**Subject: WATTS BAR NUCLEAR PLANT (WBN) UNIT 2 - FINAL SAFETY ANALYSIS REPORT (FSAR) - RESPONSE TO CHAPTER 10 REQUEST FOR ADDITIONAL INFORMATION**

**Submittal of Siemens Responses to NRC 04 Mar 2011 Requests for Additional Information - FSAR Section 10.2.3 - Turbine Rotor & Disk Integrity TVA Watts Bar #2 Completion, Upgrade & Startup Project (Non-proprietary Version)**

SECTION 10.2.3, "TURBINE ROTOR AND DISK INTEGRITY"  
WATTS BAR NUCLEAR PLANT UNIT 2 FINAL SAFETY ANALYSIS REPORT  
AMENDMENT NO. 99

Figure 1 – UT Disc Inspection of Advanced Disc Design LP Rotor

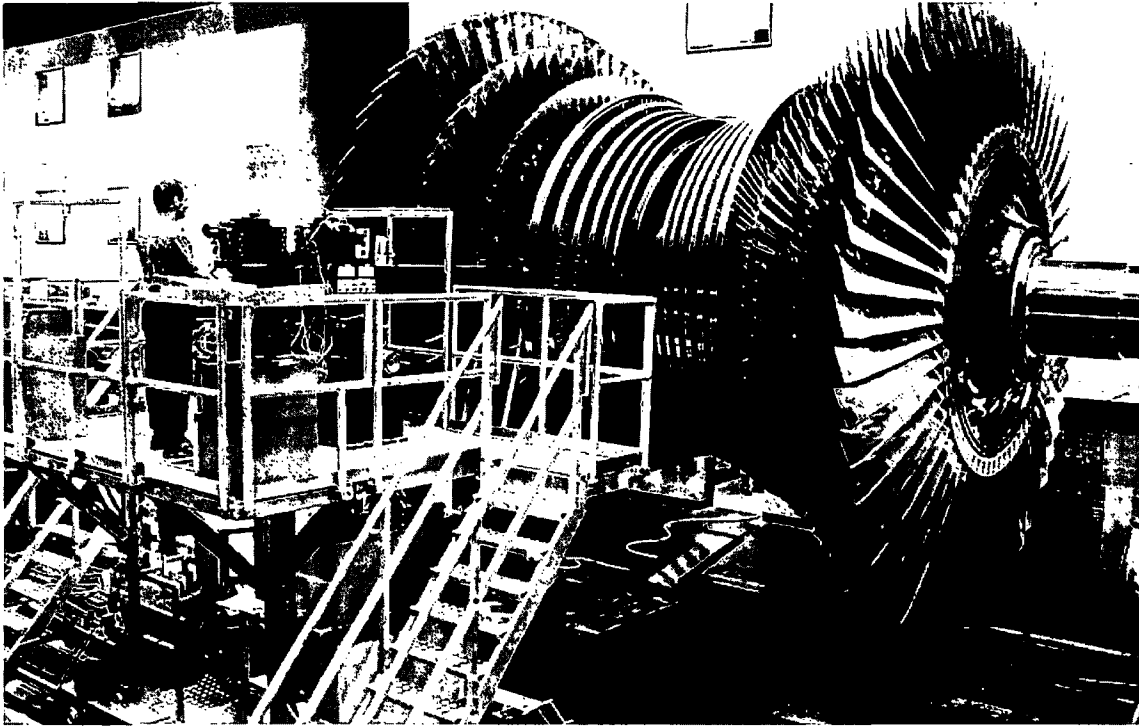
Regarding the last criterion (inservice inspection), SRP 10.2.3 requires disassembly of the turbine at approximately 10-year intervals and complete inspection of all normally inaccessible parts, such as couplings, coupling bolts, turbine shafts, low-pressure turbine blades, low-pressure disks, and high-pressure rotors. Amendment 102 does not address this requirement, please provides this information.

Siemens Comments: The NRC Safety Evaluation of the Siemens 13.9m<sup>2</sup> LP retrofit [Ref. 1] accepted LP rotor disc inspection intervals for up to 100,000 operating hours. At the first outage

following the 100,000 operating hours, it would be recommended that the LP turbine rotors be inspected by NDE, including the following areas:

- Rotor journals and shafts are inspected by VT and MT methods
- LP blades and grooves are inspected by VT and MT methods
- Shrunken-on discs are inspected by VT and UT methods – See Figure 1
- Couplings are inspected by VT and MT methods
- Coupling bolts are inspected by VT, MT and UT methods
- Bearings are inspected by VT and PT methods
